CLINTON
INITIAL LICENSE EXAM

Copy of the Letter from the Facility
Submitting Their Post-Examination
Comments

Subject: Comments Regarding Reactor Operator License
Examination Questions Administered on July 23, 2001

This letter is to request that credit be given for a second answer for questions #48 and #74 from the Reactor Operator License Examination administered on July 23, 2001. Enclosed are the questions and associated documentation that justifies this request.

Figure 12-7: Detail A

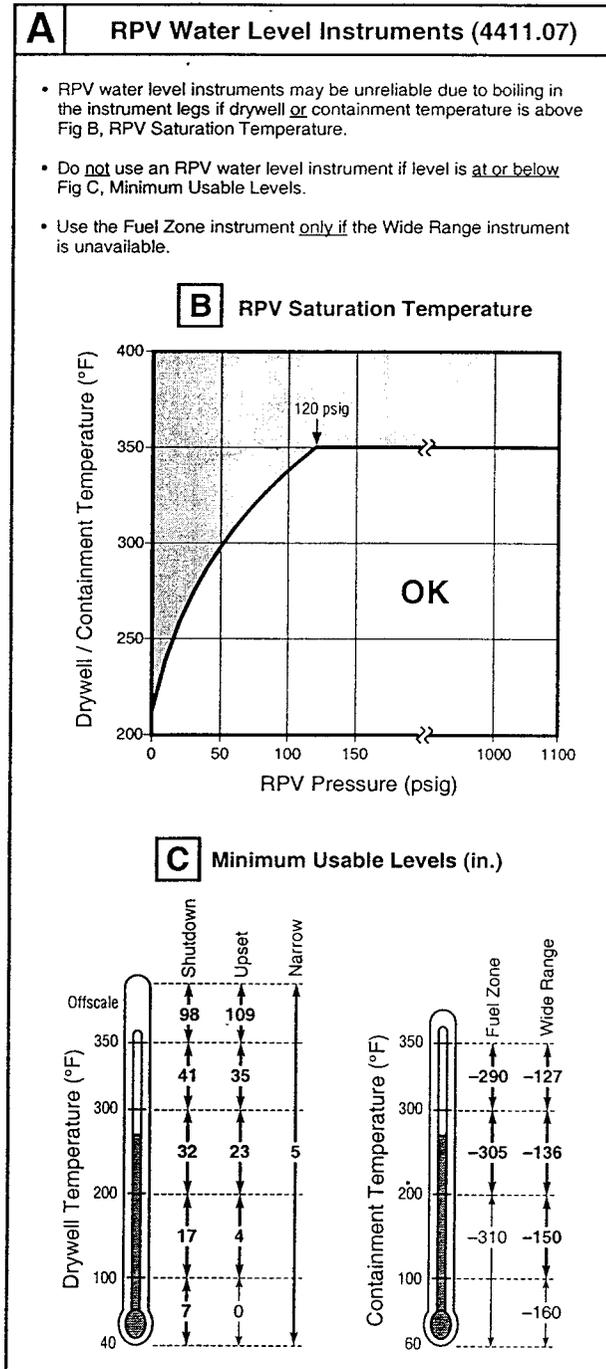
INCORRECT, level can be determined using Fuel Zone if the assumption is the same as in Answer A, but not all instruments are considered OPERABLE. All the instruments, with the exception of Fuel Zone, are at or below their Minimum Usable Level in accordance with Detail A of the EOPs and should not be used. Because they can not be used at this time, they are not fulfilling their function of indicating level. Since they are not fulfilling this function then they would not be considered Available (see attached definition). If they are not considered Available then they would not be considered Operable (see attached definition).

INCORRECT, Shutdown, Upset, and Narrow Range instruments are at or below their minimum usable level and, therefore, can not be used.
